## Department of Transportation

**Re: Safety treatment at 6<sup>th</sup> St and M St SW Intersection  
NOI# 25-126-MSED**

**Figure 1:** Proposed bicycle lane shift, lane reduction, green bicycle markings, and left turn traffic at 6<sup>th</sup> St and M St SW

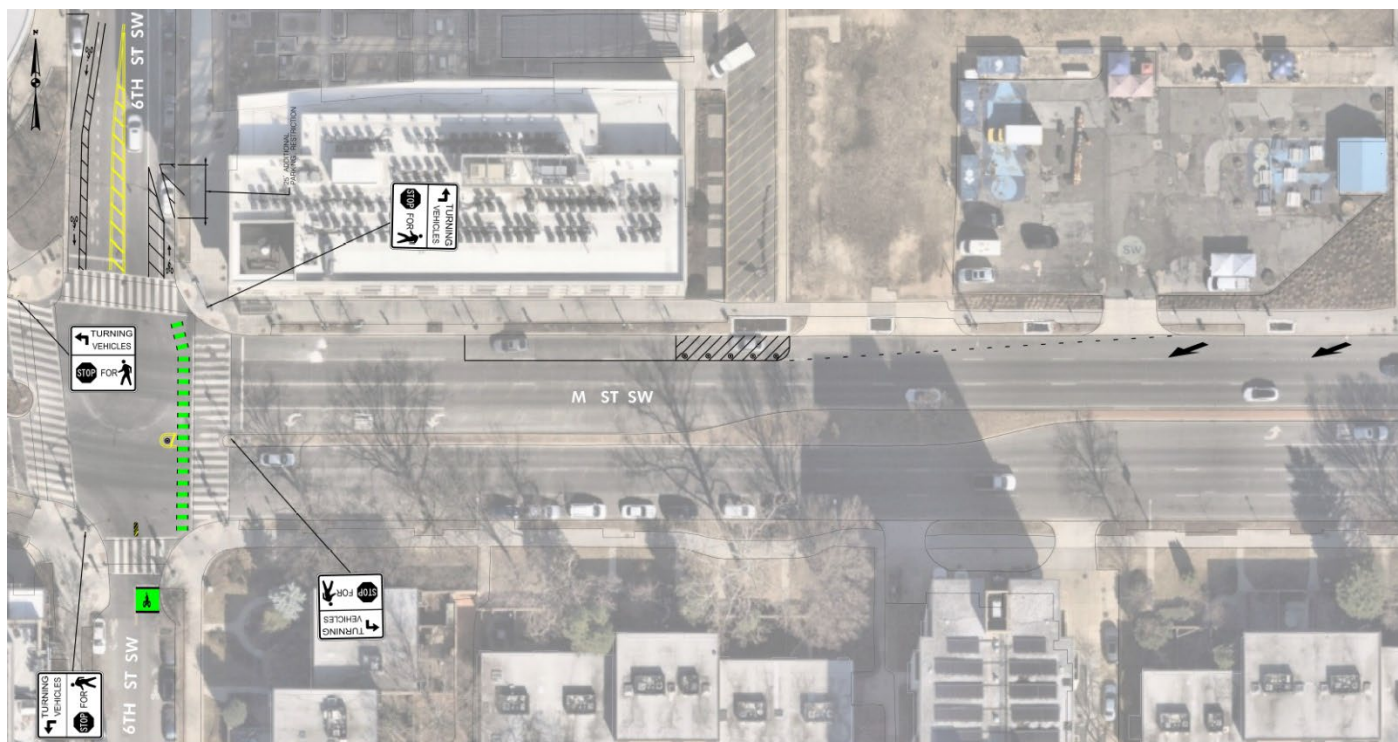
- **A 25-ft parking restriction on northbound 6<sup>th</sup> St SW past M St SW intersection**
- **Converted the rush hour restricted parking on westbound M St SW to full time parking**

- Shift existing bike lanes on 6<sup>th</sup> St SW to curbside and proposed green bicycle markings across the intersection to reduce crossing widths and enhance bicyclist safety
- Left turn traffic calming measures using signs, rubber bumps, yellow marking, and flex-posts to ensure drivers take a more right-angled turn, improving visibility
- Bicycle box on northbound 6<sup>th</sup> St SW to provide a safer waiting area for bicyclist
- Reduced the three through lanes to two on westbound M St SW, between 5<sup>th</sup> and 6<sup>th</sup> St SW. This will help reduce speeding along the block and rush hour traffic can be accommodated with remaining lanes.

The proposed improvements will require the restriction of 25 ft of parking (approximately one parking space) on northbound 6<sup>th</sup> St SW in addition to the existing 25 ft parking restriction from the crosswalk. The parking restriction is required to shift the existing bike lane on north bound 6<sup>th</sup> St SW to the curb side, but replaces it with new full time parking on the adjacent curbside on M Street SW. As part of the proposed change to the number of through lanes, from three to two, we have proposed to change rush hour restricted parking on westbound M St SW, between 6<sup>th</sup> and 5<sup>th</sup> St SW, to full time. The proposed

safety treatments will enhance driver's awareness of the presence of bicyclists as well as reduce conflict between turning vehicles and pedestrians.
